City of Woodland

Planning Commission

Thursday, March 3, 2016

Lennar; The Crossing at Spring Lake

PLAN 2713

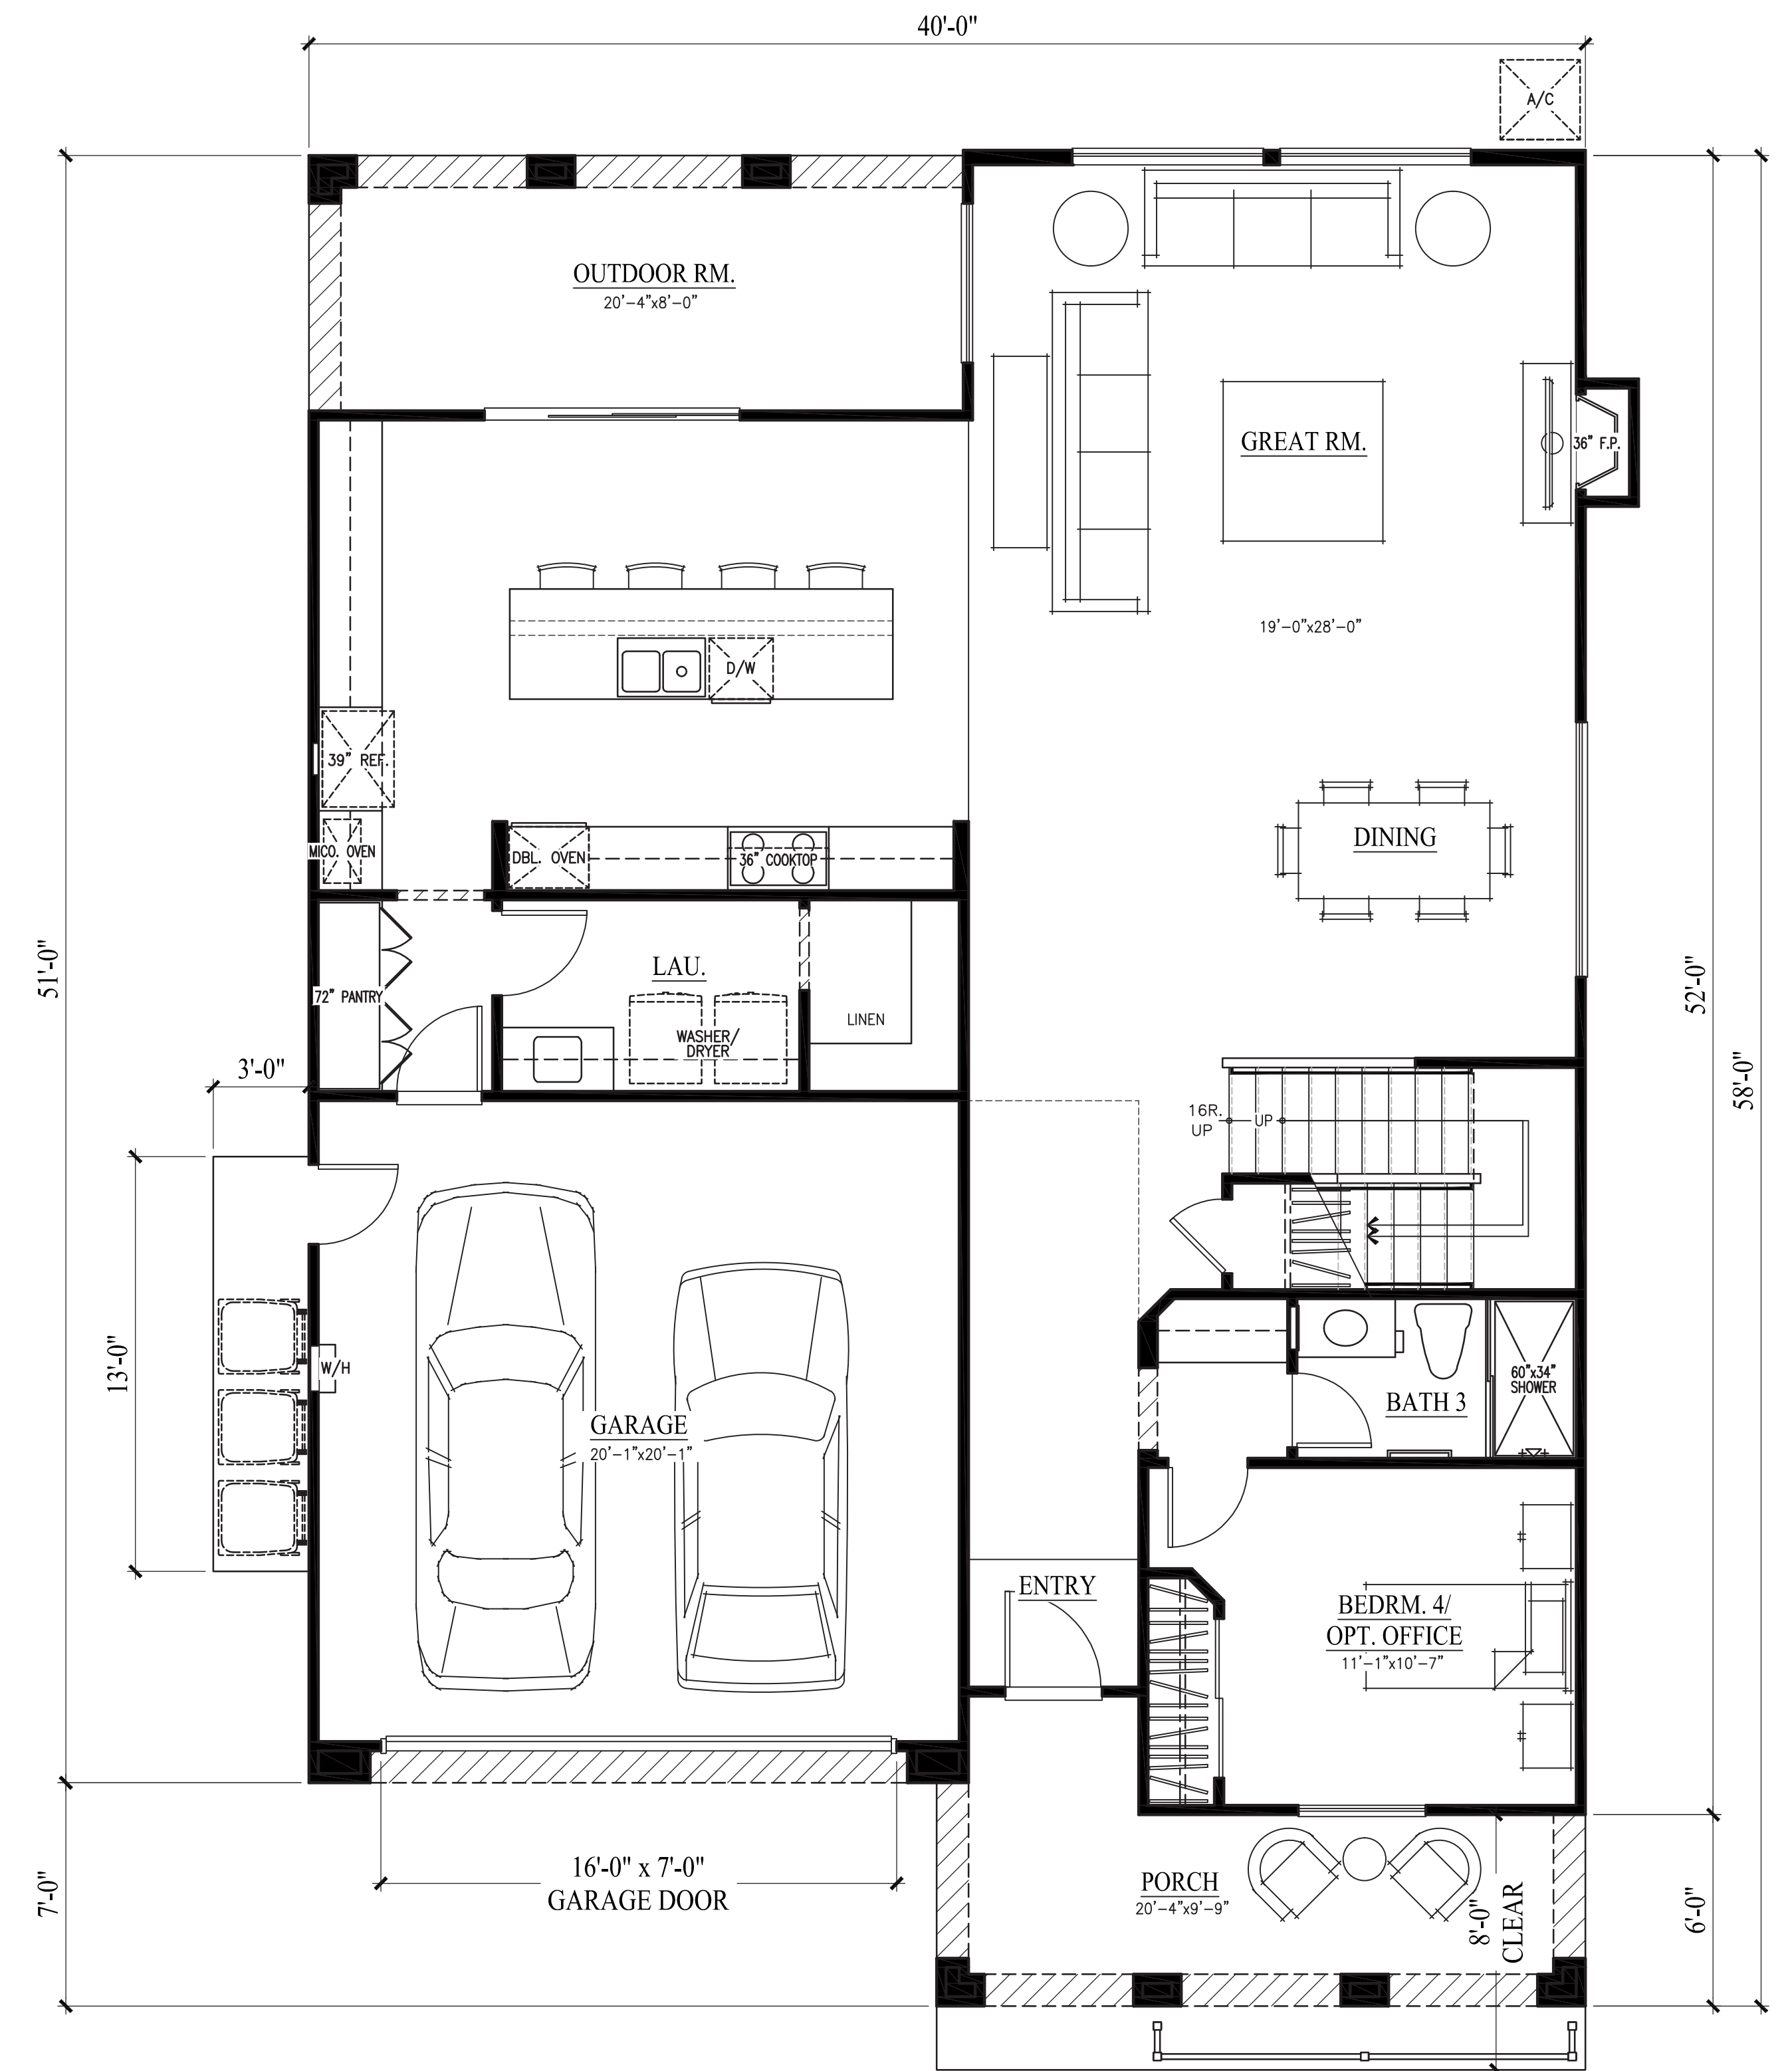
increased porch areas can be achieved while respecting other requirements such as setbacks and lot coverages. A condition of approval (COA #3) has been added to address this matter. The plan submittal includes a variety of garage door designs, driveway patterns, as well as varying roof pitches. Roof pitches range from 3:12 to 6:12.

- COA #3** Prior to issuance of building permits the applicant shall work with Staff and the Design Liaison in the design of the front porches for Plans 2461 and 2713 to substantially meet minimum size requirements.
